Our ref: DOC25/185456-8

MT PIPER POWER STATION – ENERGYAUSTRALIA Operational Efficiency Improvements – Mod 9 (DA 80-10060)

ATTACHMENT 1 – PROPOSED CAPPING STRATEGY

1. Capping Design

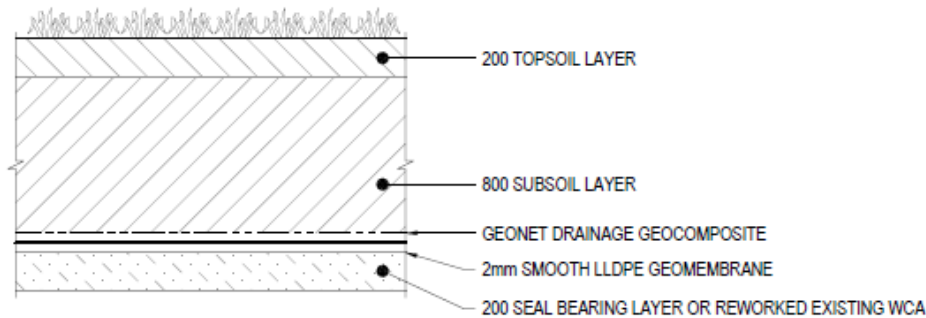
The currently approved design includes the application of 200mm of WCA directly over the top of the BCA. This was approved in 2008 and does not reflect contemporary practice for capping ash repositories. The proposed capping system now includes a 200 mm seal bearing layer, 2mm LLDPE membrane, geonet drainage and 800mm soil layer (see schematic below). This is a significant improvement over the currently approved design.

TYPICAL CAPPING SYSTEM PROFILE

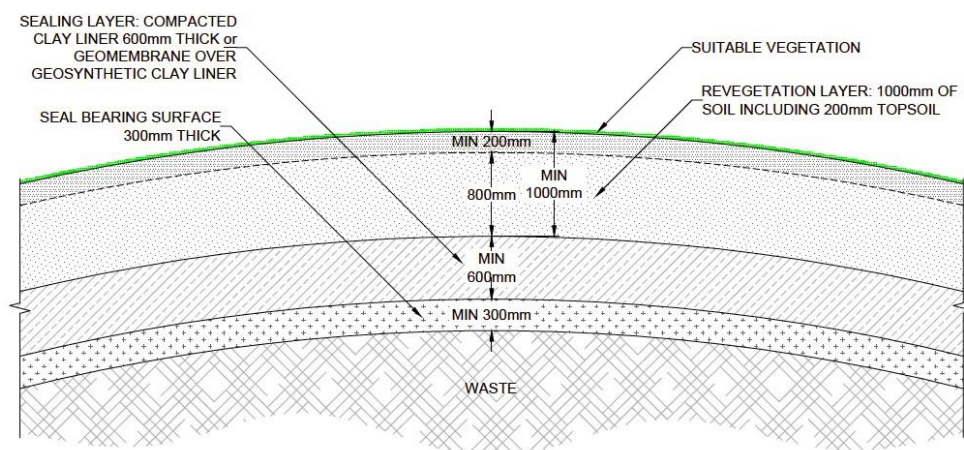
The capping profile is consistent with the minimum design specifications outlined in the Environmental Guidelines for Solid Waste Landfills (2016) apart from the omission of a geocomposite clay liner. This is usually required when a geomembrane is proposed to be used in the capping profile. The standard capping profile outlined in the Environmental Guidelines for Solid Waste Landfills is shown in the diagram below. The sealing layer includes either 600mm of clay or this can be substituted for a geocomposite clay liner (GCL) in combination with a polyethylene geomembrane (either HDPE or LLDPE).

The omission of the geocomposite clay liner (GCL) was considered based on the properties of the ash and the secondary containment systems in place to manage the leachate which may be generated. The Brine Conditioned Ash (BCA) has a permeability of $3 \times 10^{-7} \text{m/s}$. This will mean that any infiltration through LLDPE and underlying BCA will be very slow and provide a similar outcome to the use of a GCL. It is also noted that there is a base liner and leachate capture system in place to address any infiltration through the cap.

Based on these considerations the proposed modification is supported.
